**ADDENDUM NO: 3**

PROJECT: Clarksville Community Schools Interior Improvements

PROJECT NO: 2025014 DATE: 08/22/2025

DRAWING TITLE: FINISH LEGEND & DETAILS

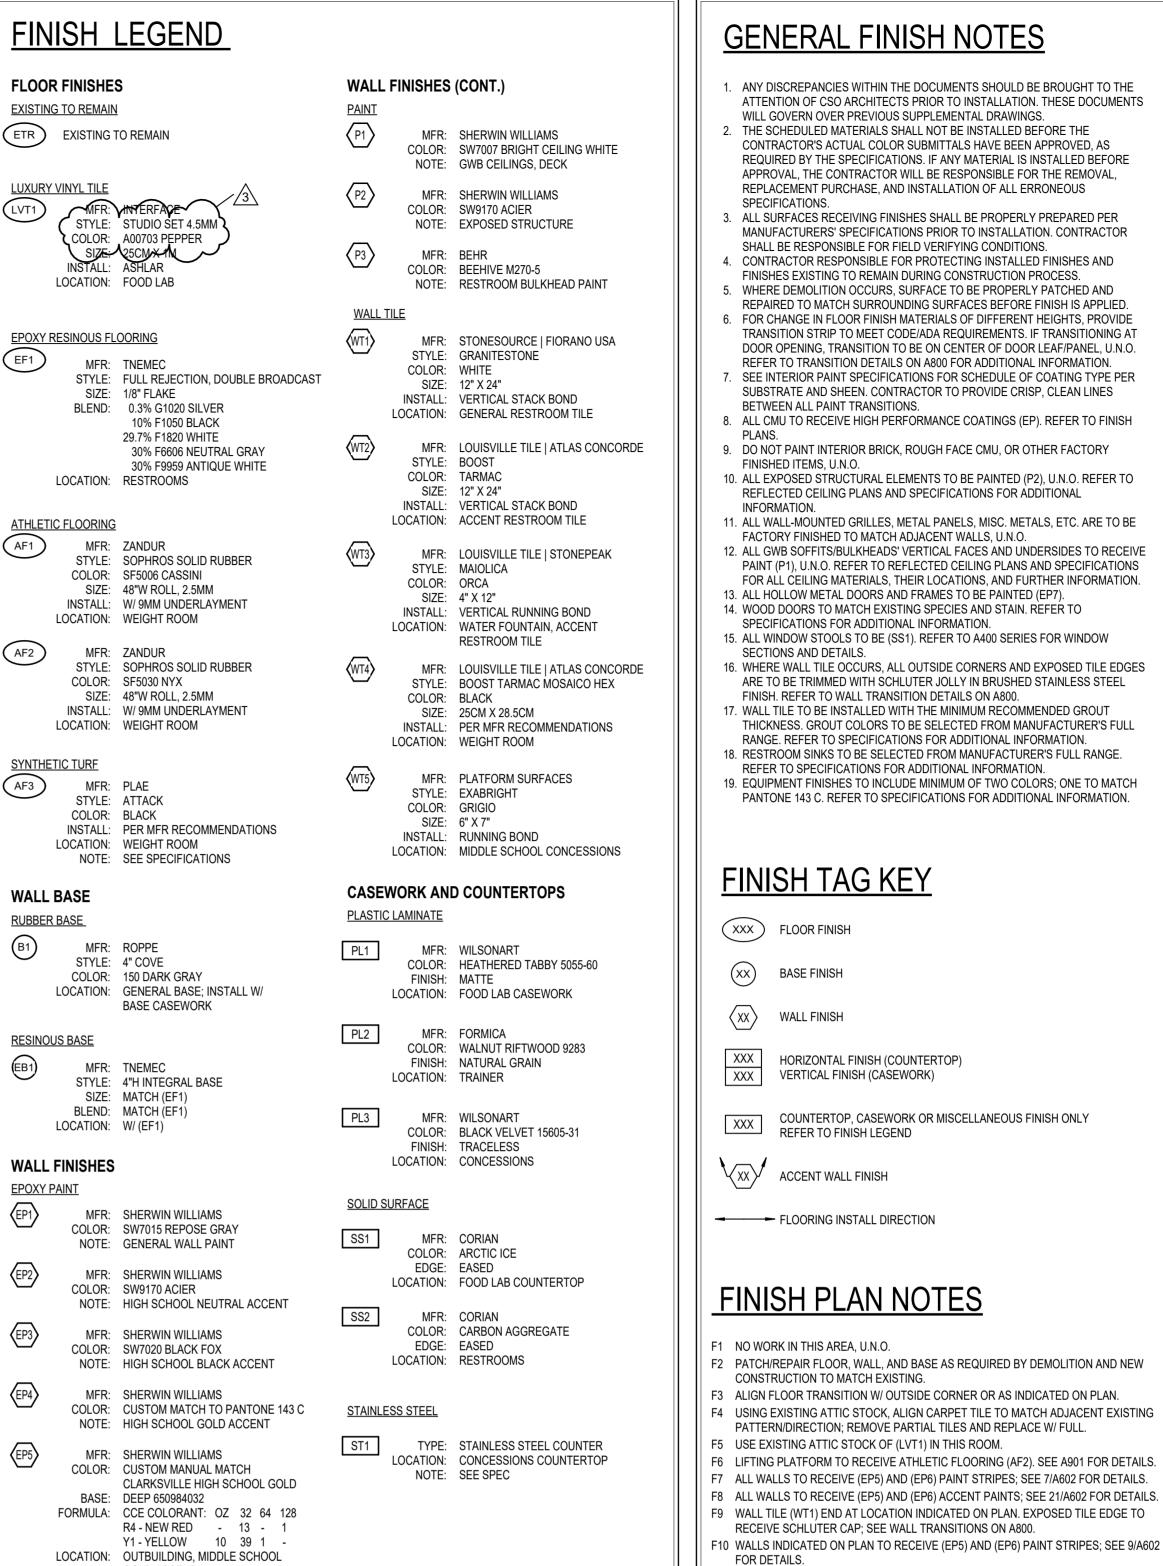
- 3.1 <u>A800 GROUND FLOOR PLANS</u>
  - A. **Add** "4.5MM" to 'LVT1' Style in Finish Legend.
  - B. **Revise** color of 'LVT1' to "A00703 PEPPER".
